**SUSITNA  
HYDROELECTRIC PROJECT**

(PROJECT NO. 7114-000)

RESPONSES TO  
THE DEPARTMENT OF THE INTERIOR  
COMMENTS ON LICENSE APPLICATION

February 15, 1984

FIGURE E.3.85

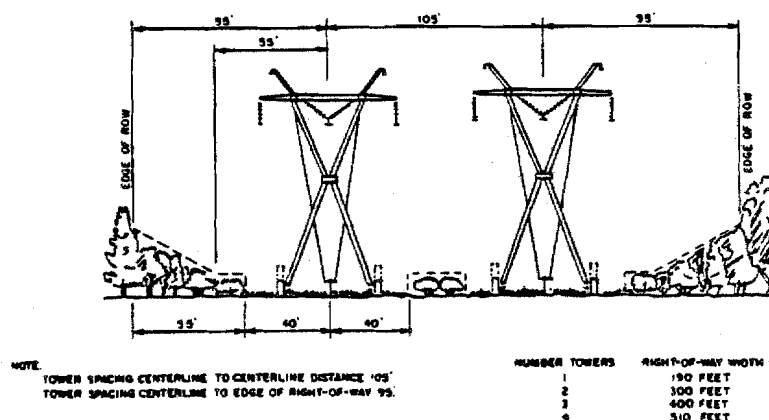
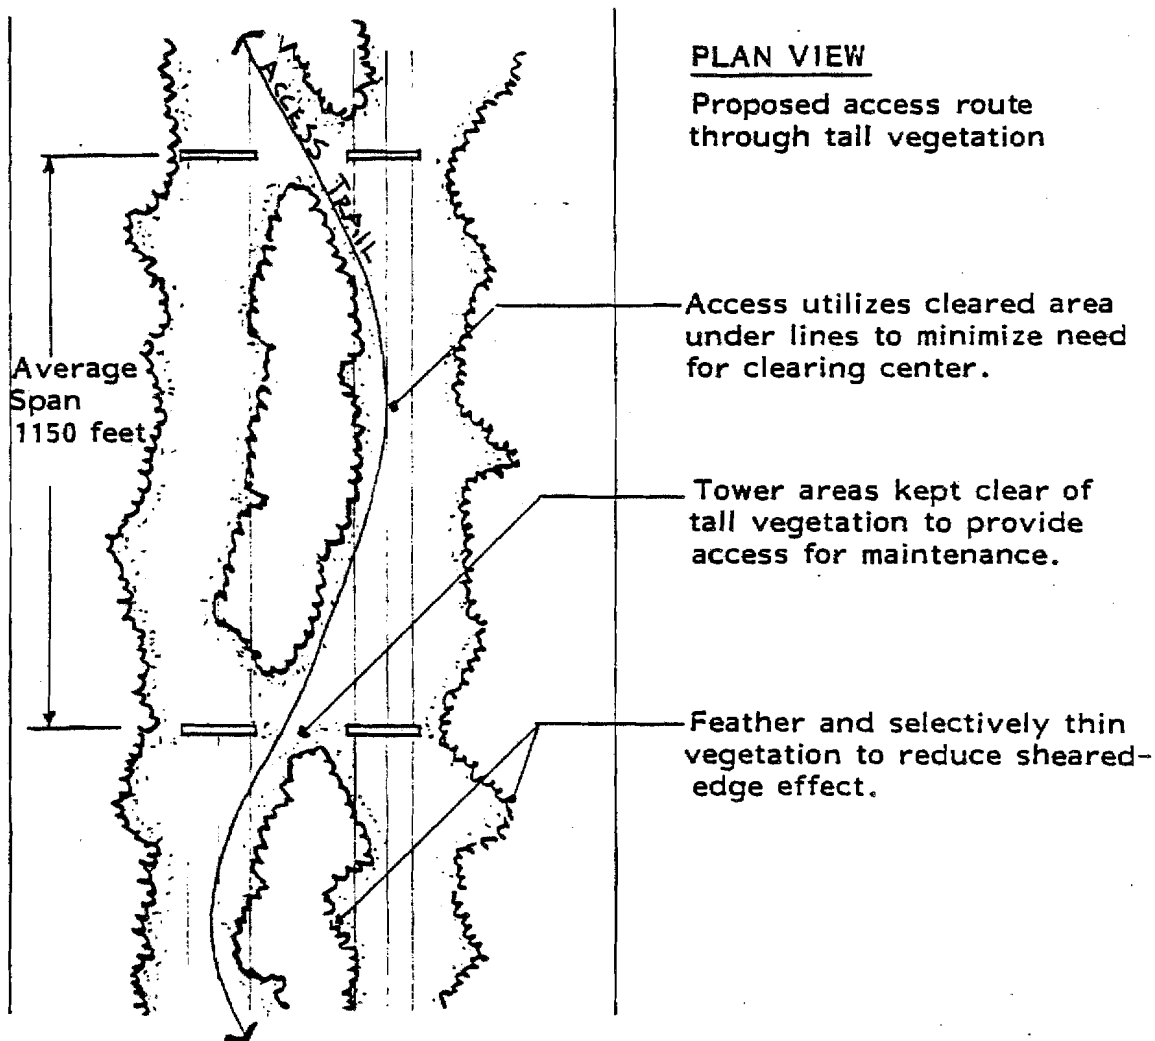
"Page E-3-493: 4.3.4 - Transmission Lines: Paragraphs 2 and 3: To minimize clearing requirements along the transmission corridor, we recommend that the 25-foot maintenance access trail be adjacent to the towers, in the area where vegetation will be kept to a minimum height. The applicant should provide the anticipated schedule and height criteria for safely maintaining vegetation clearing along the line. Opportunities to alter the schedule to maximize production of early successional vegetation types for moose and black

"The referenced map of the transmission corridor (Figure E.3.37) is incomplete. We suggest addition of an overview map showing the locations of Figures E.3.48 through E.3.52.

Final routing of the access trail for the transmission line will be determined by site specific data obtained through field investigations during the detailed construction planning for the line. It is anticipated that in areas of tall vegetation and, where allowable, due to terrain conditions, the access trail will follow the pattern shown in the attached Concept For Construction/Maintenance Access. Anticipated clearing heights are described in FERC License Application Exhibit E, Chapter 9, page E-9-48. Presently, the schedule for maintaining vegetation height standards is anticipated every ten years at a maximum. Final schedules for maintenance of the right-of-way will be determined by the operating contractor and will provide for flexibility depending on identified circumstances. FERC License Application Figure E.3.37 shows only the transmission line route between Watana and Gold Creek (the immediate project site). The complete transmission line route is referenced in FERC License Application Exhibit G, Plates G.30 through G.52. These maps are keyed to an overview index map shown in Plate G.4.

AREAS OF CURRENT SLOPE INSTABILITY

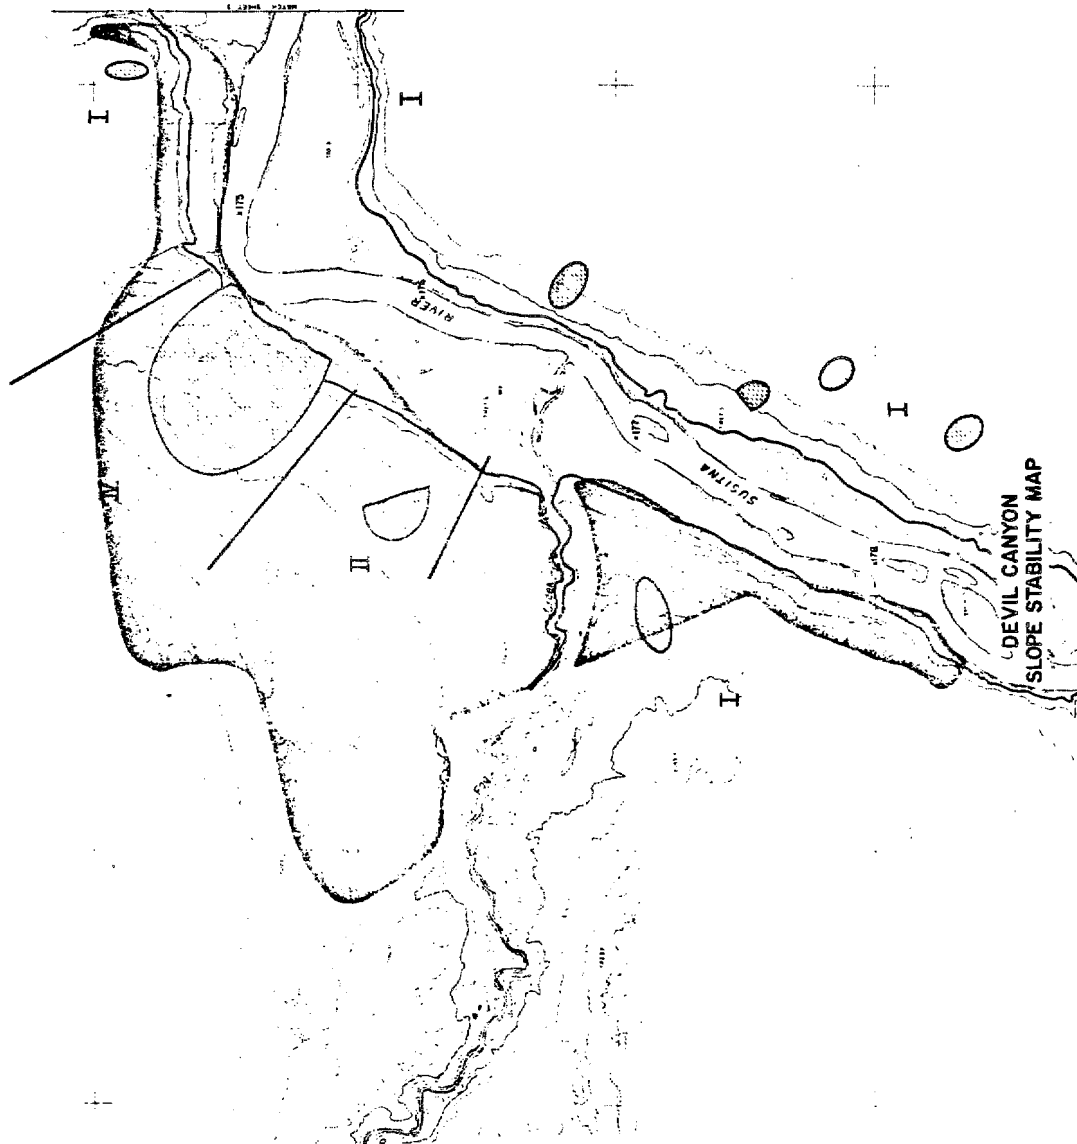
"Page E-3-242: Filling and Operation: Paragraph 3: We find no delineation of the large landslide at RM 175 on Figure E.3.3. as referenced here."

The figure reference for the old landslide at River Mile 175 should be: FERC License Application Exhibit E, Chapter 6, Figures E.6.27. A copy of that Figure is attached.
